1999 SEMINAR INFORMATION
"TECH ON TIME FOR '99"
INDEX
FORD & Chrysler

1999 SEMINAR INFORMATION

"TECH ON TIME FOR '99"

In this third manual on "TECH ON TIME FOR '99" seminar, we begin with FORD'S new 4R100. A look at the E4OD, AX4S/AX4N, AODE/4R70W and the 4R44E transmissions are just a portion of the information provided in this section of the seminar. Updates and part changes, problems and fixes for FORD transmissions fills this manual with valuable information. This manual concludes with information on Chrysler units including a look at the new 45RFE.

LUBE ORIFICE PLUG
FORD PART NUMBER
F81Z-7E380-AA

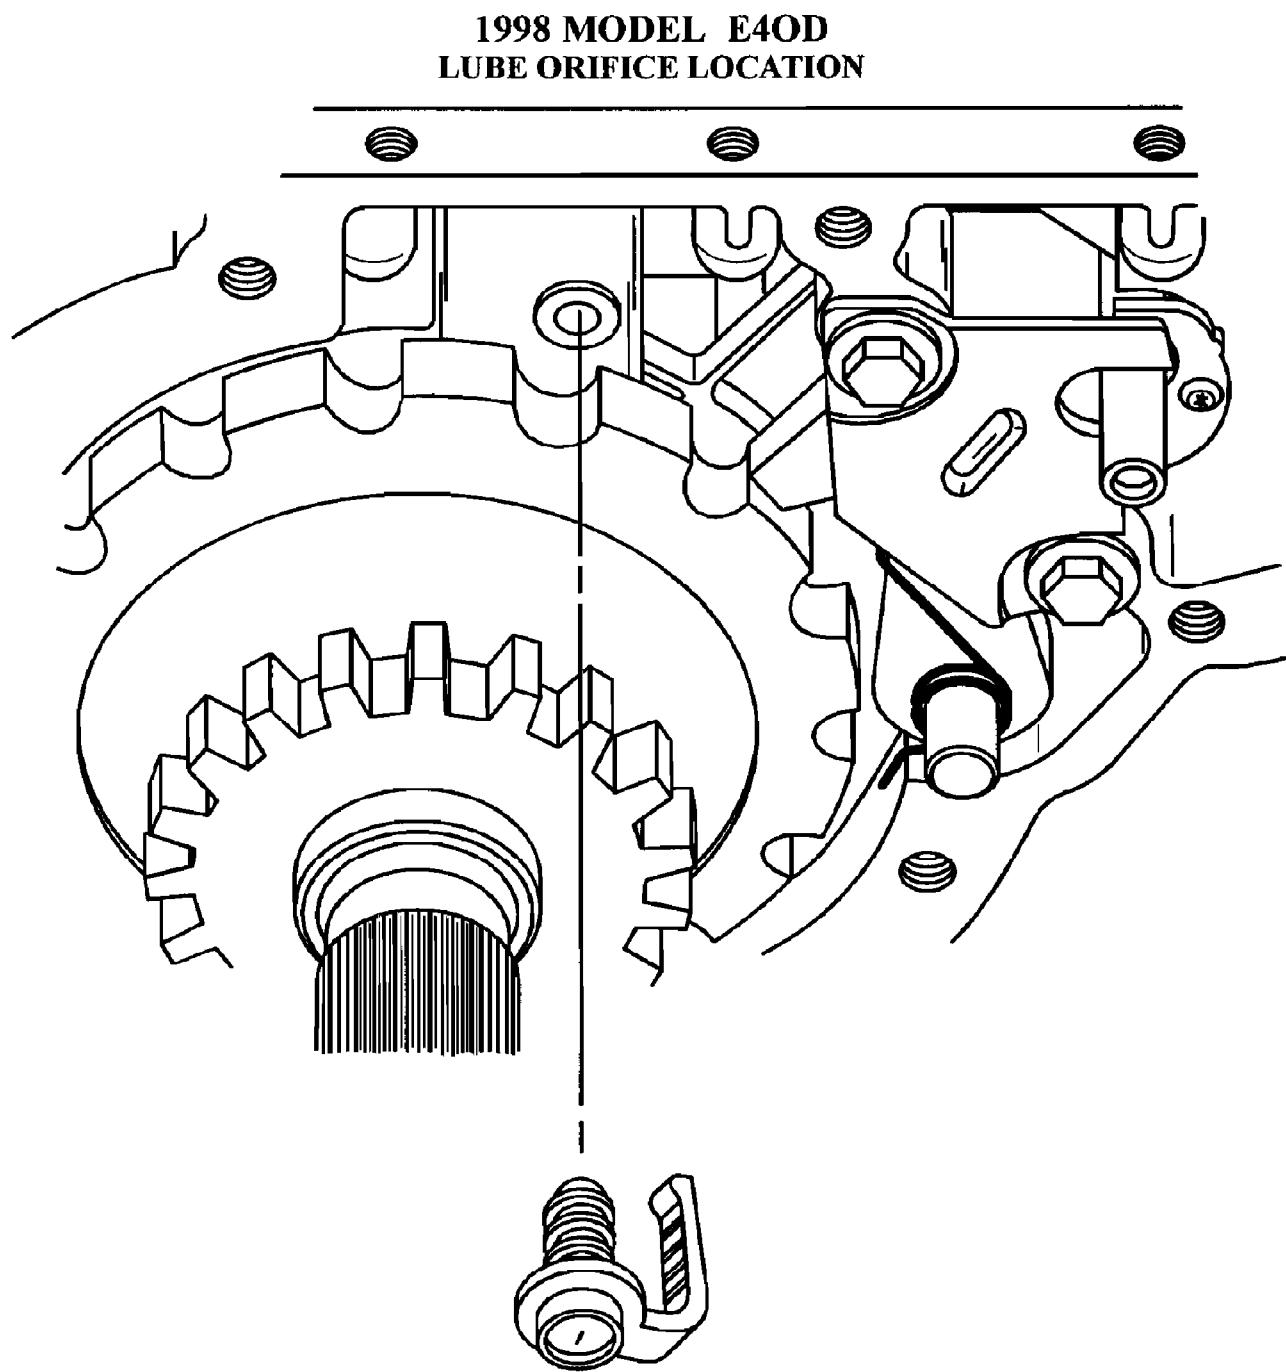
- (1) TRANSMISSION CASE - Added passage at the rear of transmission case to accept the added plastic lube orifice plug, as shown in Figure 1.
- (2) EXTENSION HOUSING - Added cast-in shoulder/boss that retains the added lube orifice plug in the transmission case, as shown in Figure 2.

- (1) The new design extension housing *with* the added cast-in shoulder or boss will service *any* E4OD transmission case, past or present (See Figure 2).
- (2) The previous design extension housing *without* the cast-in shoulder or boss can only be used on transmission cases built prior to 7/24/97 not having the lube orifice plug (See Figure 2).

Figure 1

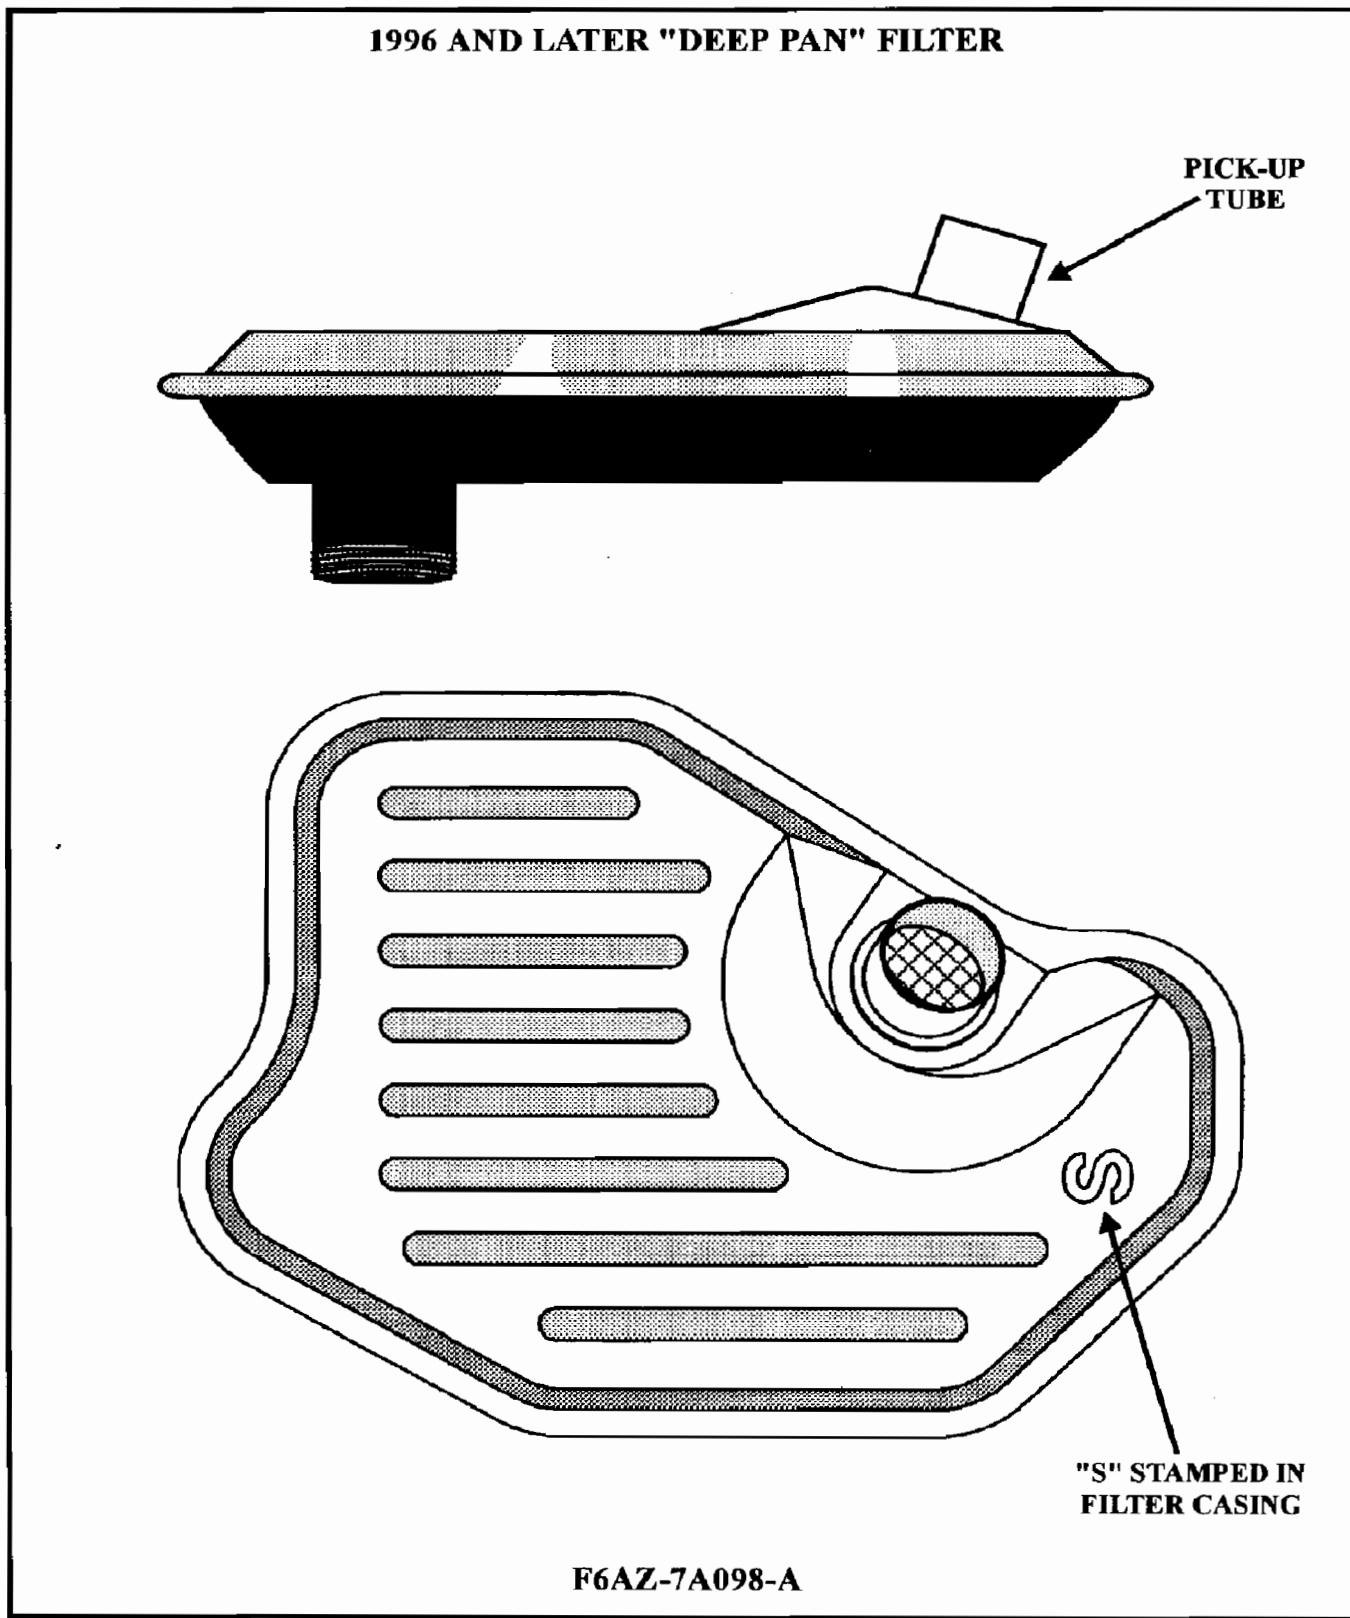
CAUSE: At the start of production for the 1996 model year both 2WD and 4WD vehicles equipped with AODE/4R70W transmissions are fitted with a new "DEEP PAN" and require the new design filter with a pick-up tube located on the pan side of the filter as shown in figure 1.

This filter must be used with the new design "DEEP PAN" and can be identified by the "S" stamped in the filter casing and can also be seen in figure 1.

Figure 3

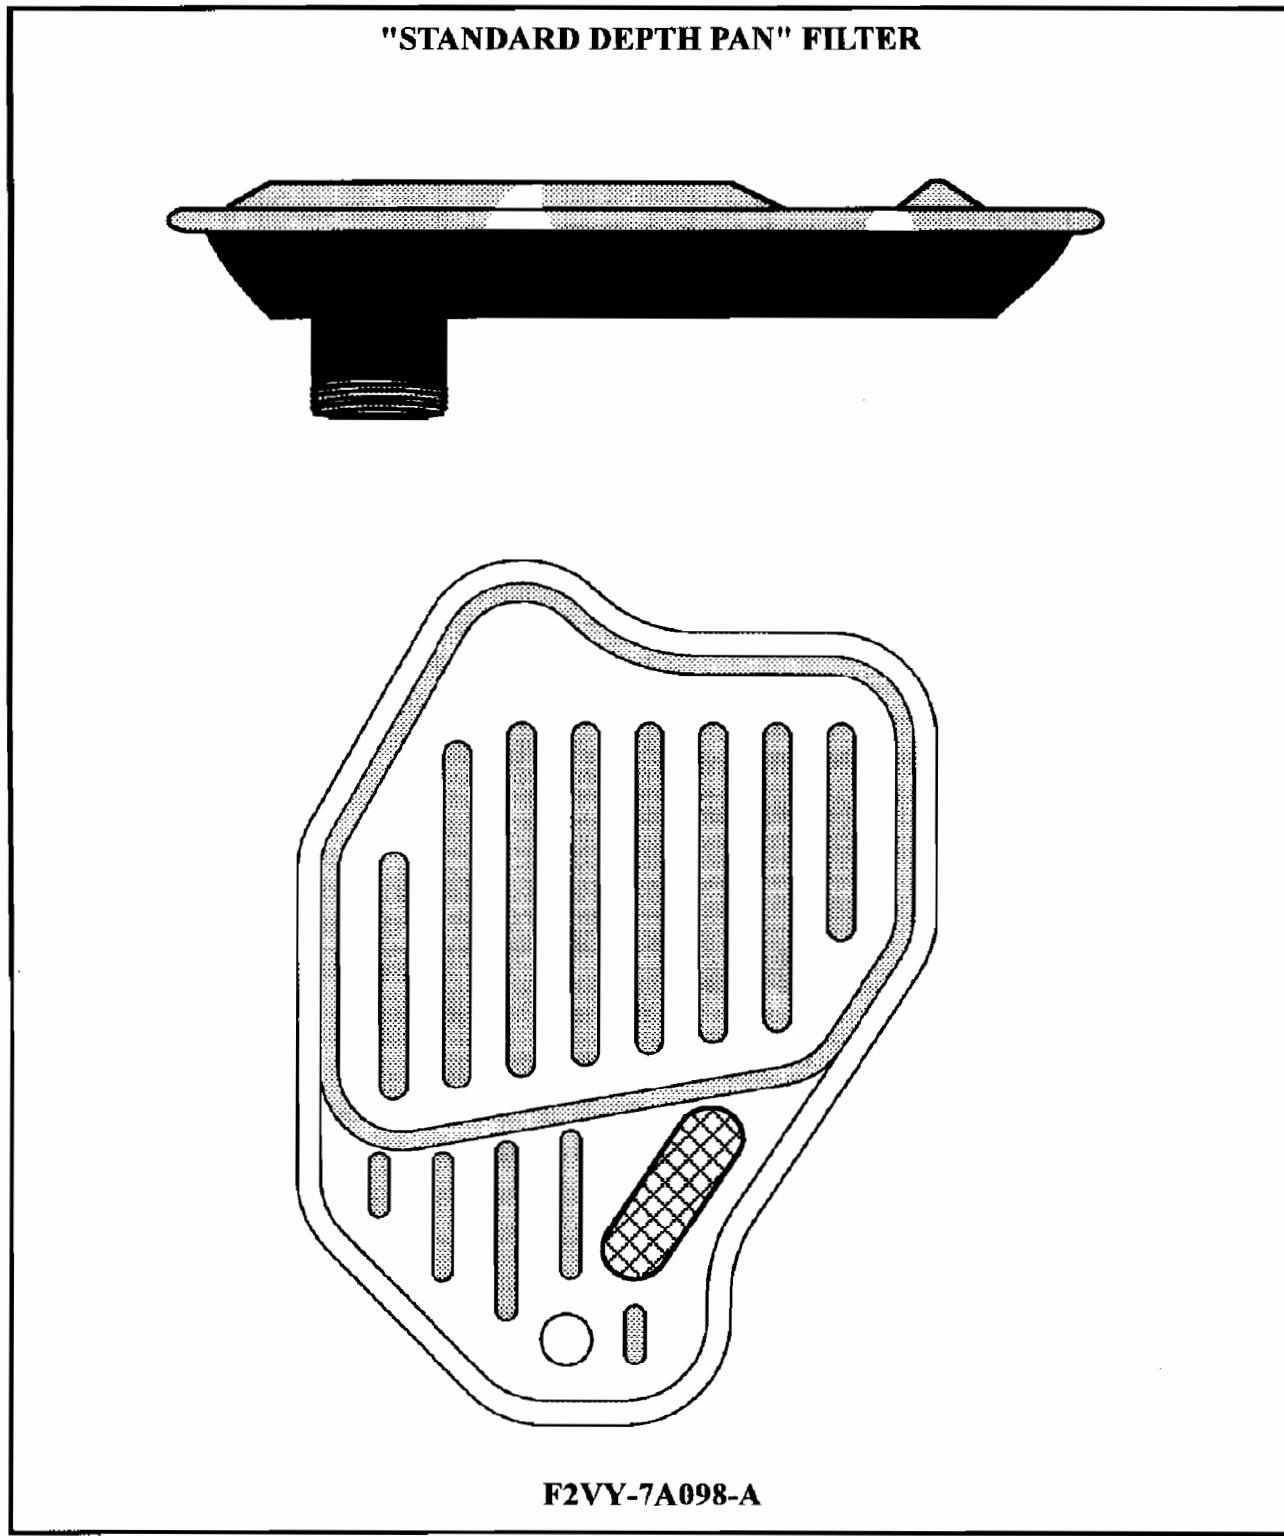
The standard depth pan filter is illustrated in figure 3, OE part number **F2VY-7A098-A** or Filtran part number **F-230**, and should ONLY be used in the shallow pan application.

When replacing the filter on any standard depth pan unit, be sure to use the filter shown in figure 3.

Figure 2

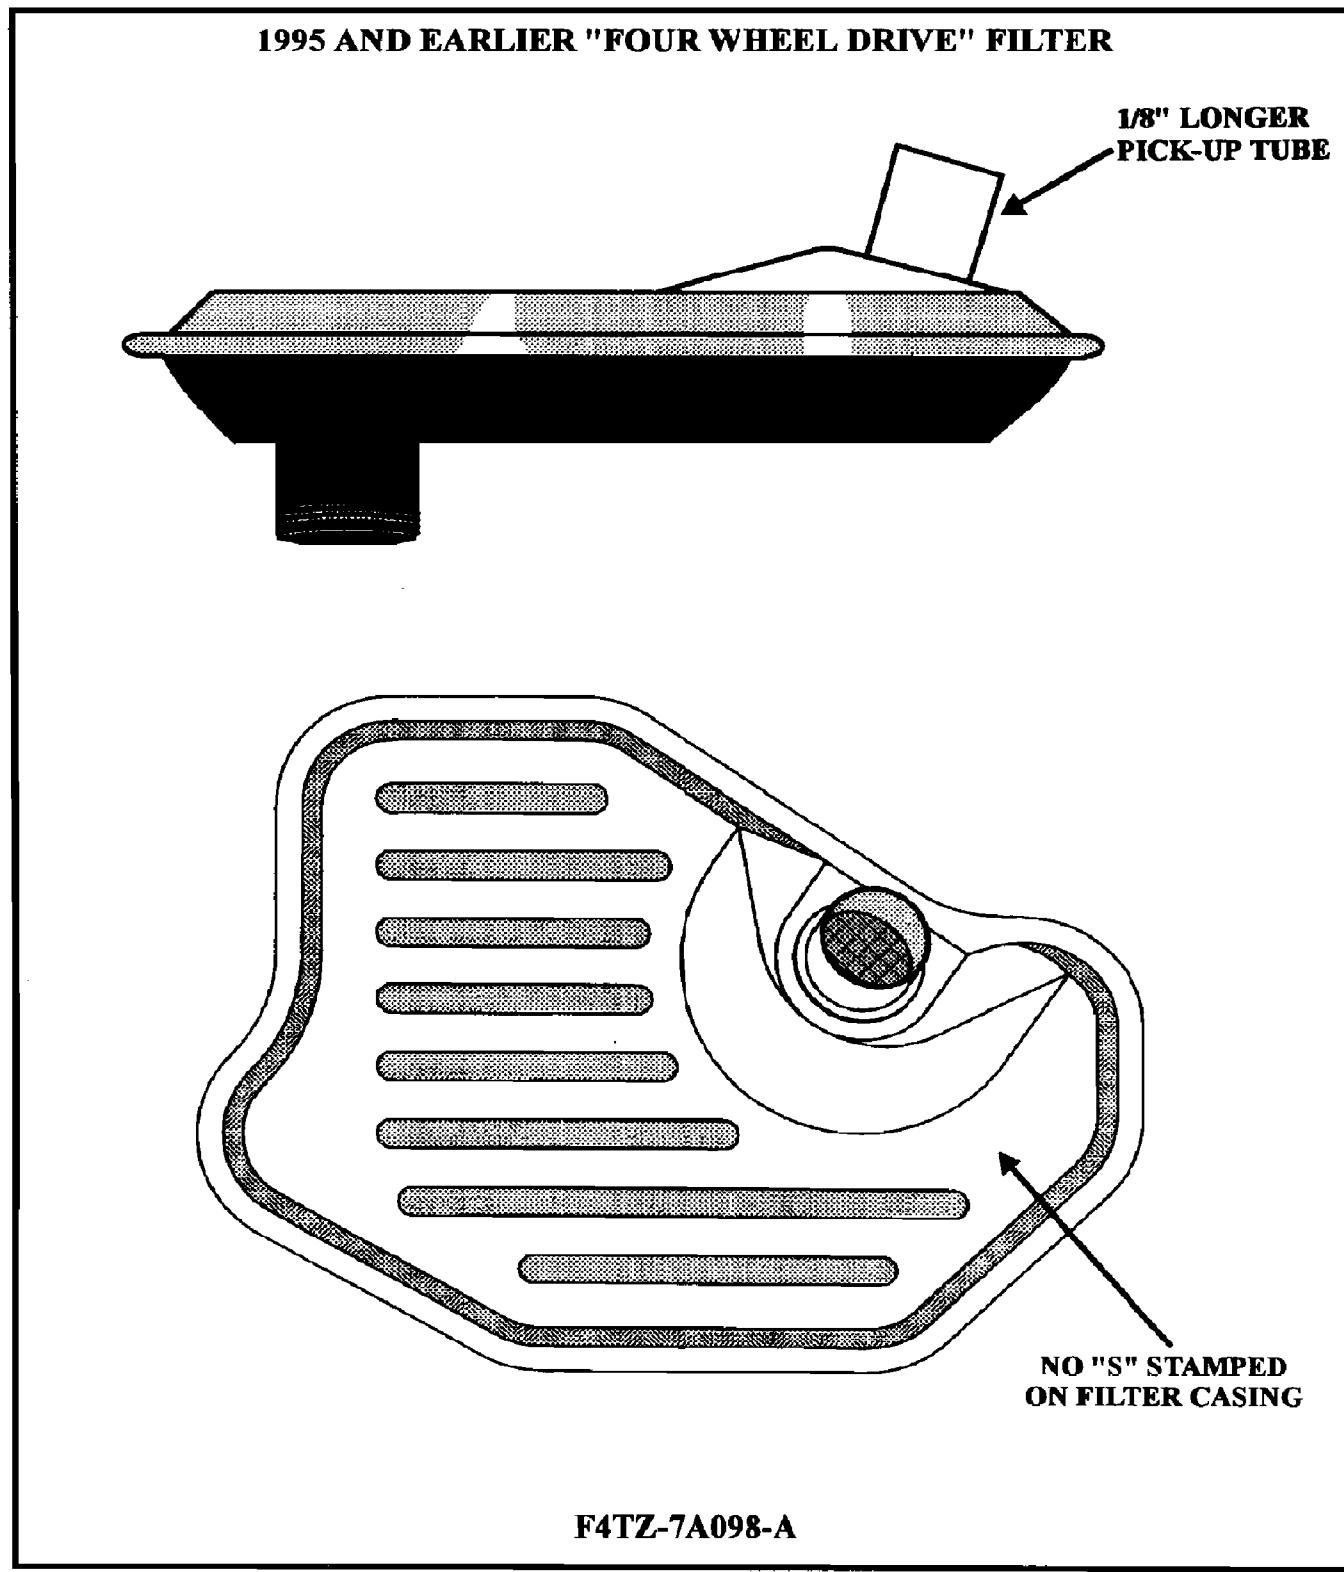
The previous design 4WD filter, part number **F4TZ-7A098-A**, should NEVER be used in a 1996 or later "DEEP PAN" unit because the pick-up tube is 1/8" longer than the new design "DEEP PAN" filter as shown in figure 2.
